July 18, 2017 GH17563-G

Subject: Response to City of Los Angeles Review Letter, Proposed Private Street

1437 for Access to 1830 N. Blue Heights Drive; PT NE 1/4 Sec 7, T1S,

R14W (Arb 23); 1830 N. Blue Heights Drive, Los Angeles, California.

**GEOLOGIC MAP 1 CIVIL ENGINEERING**

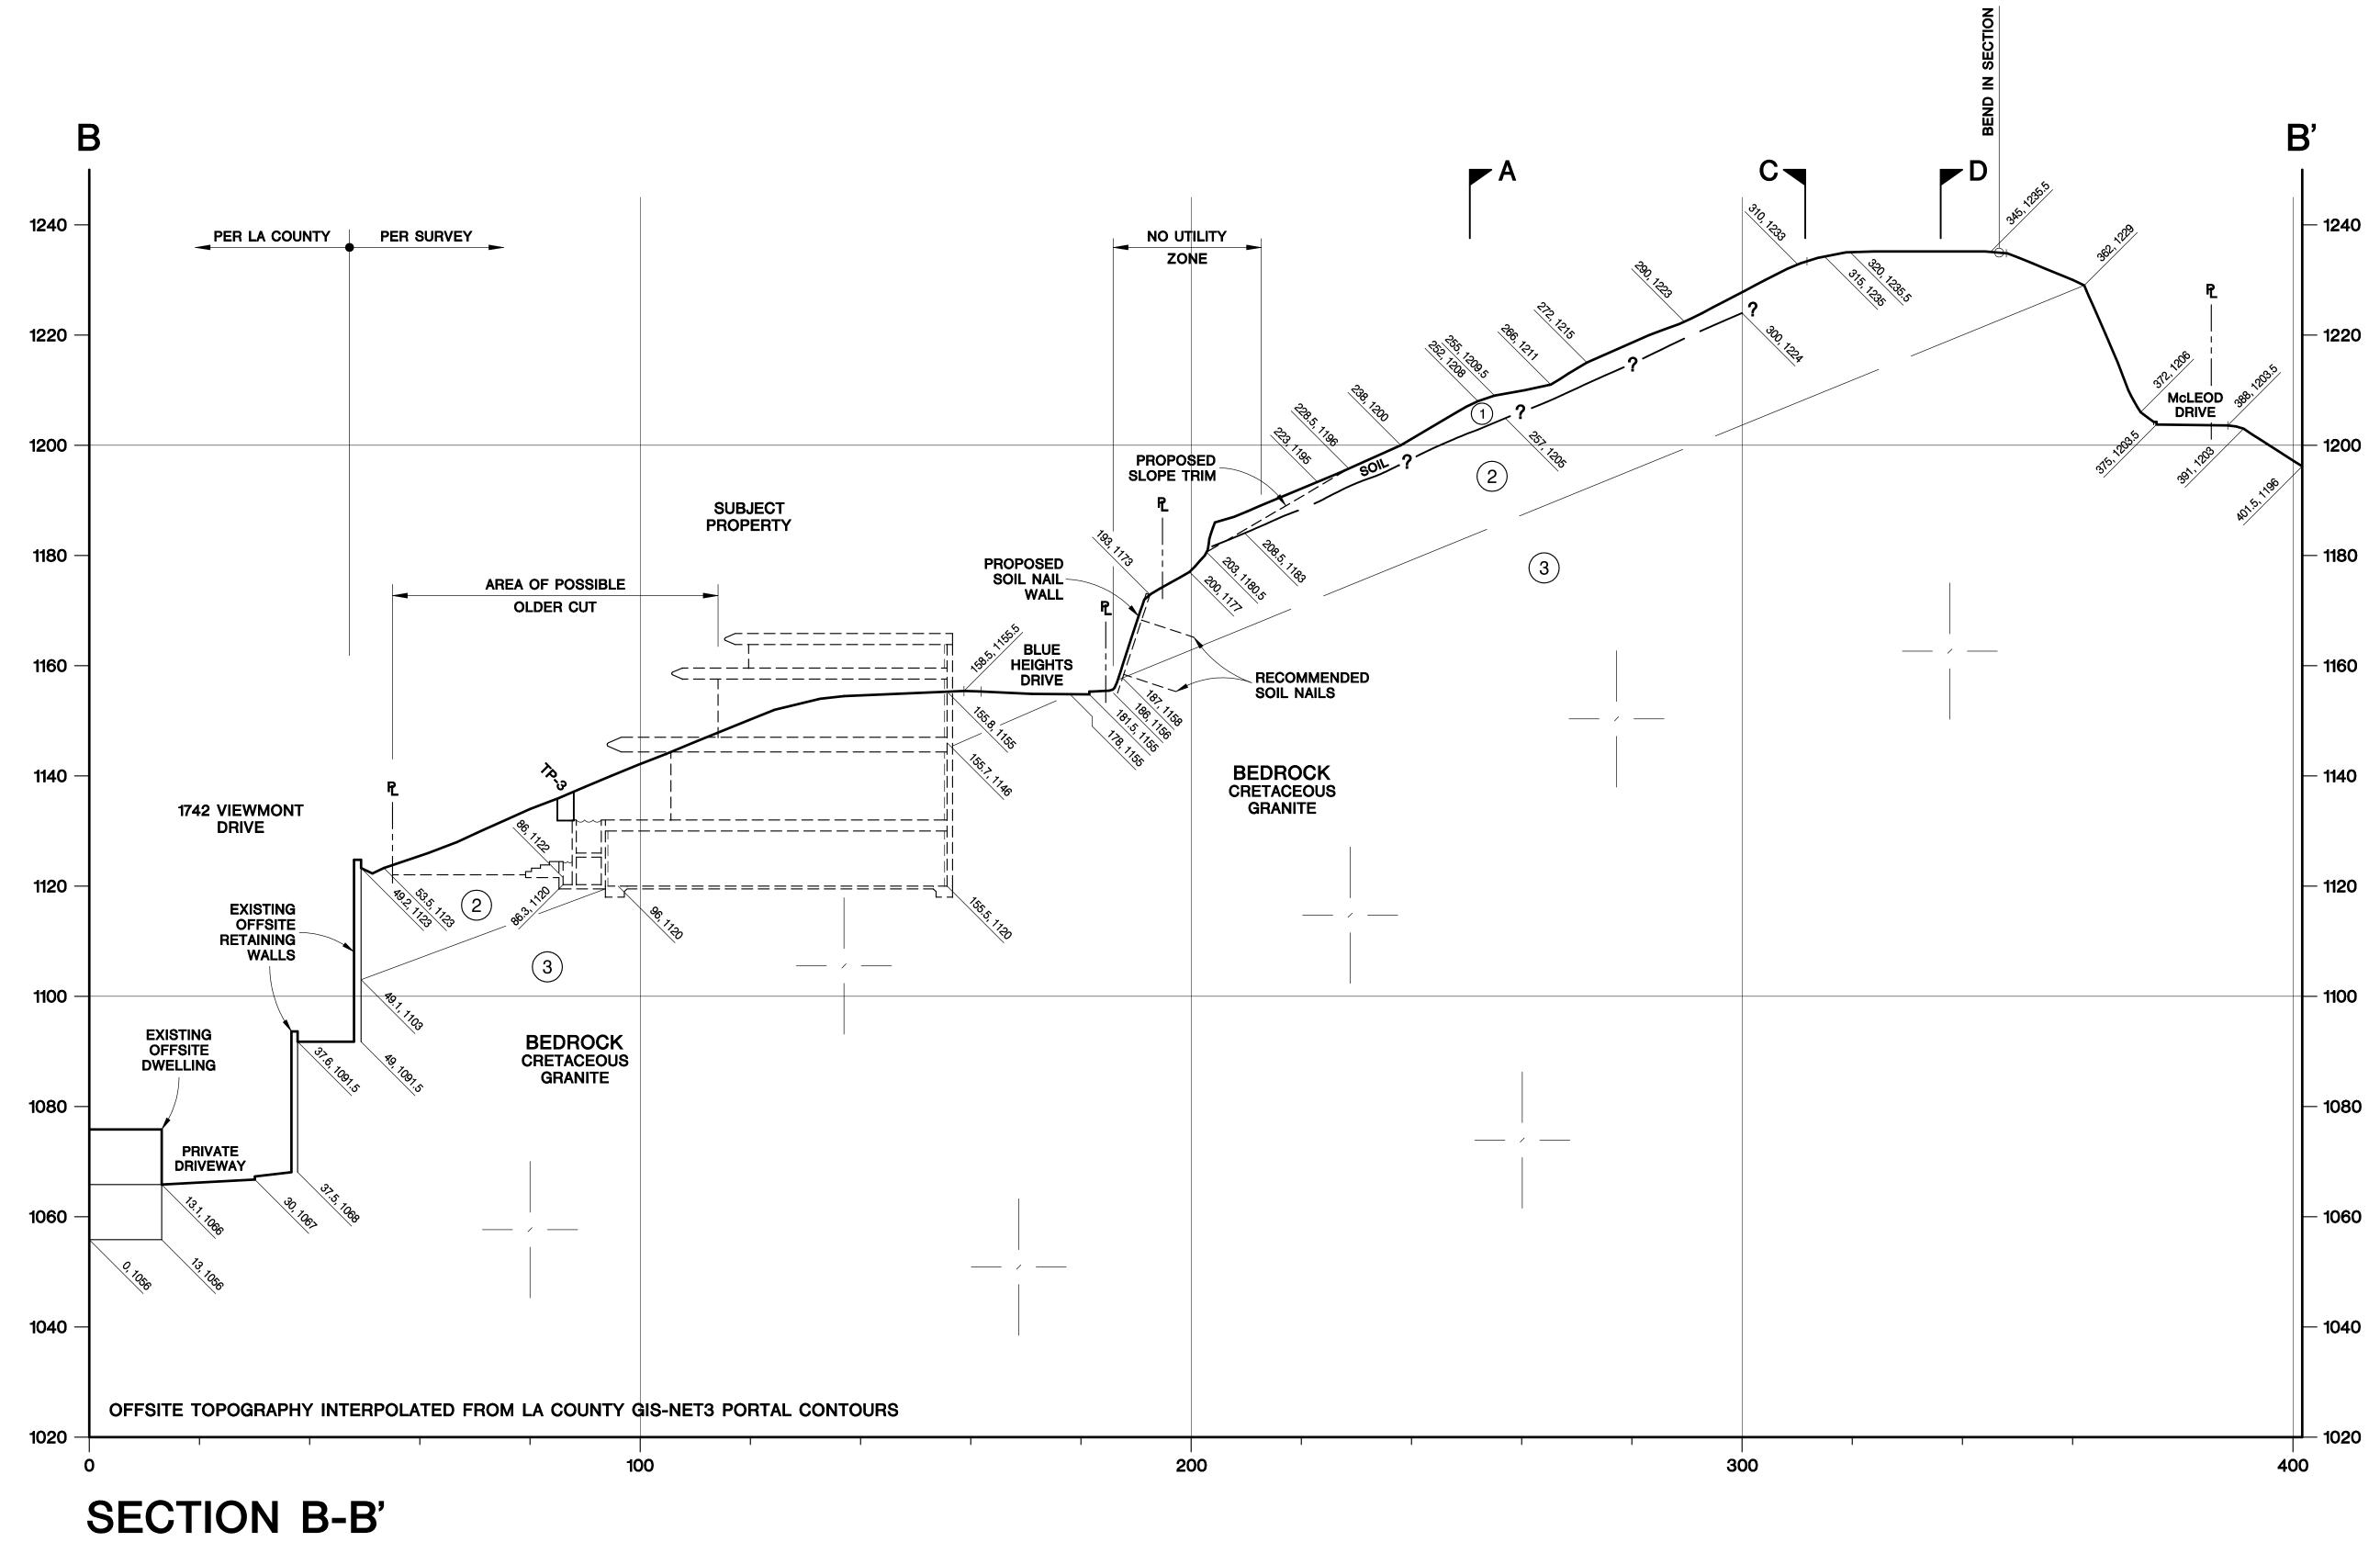
*Item 2:* Revise the Private Street Map to include all the proposed retaining, slough and soil nail walls.

**Response:** The current Civil Plan for the Private Street depicting the proposed retaining, slough and soil nail walls is attached.
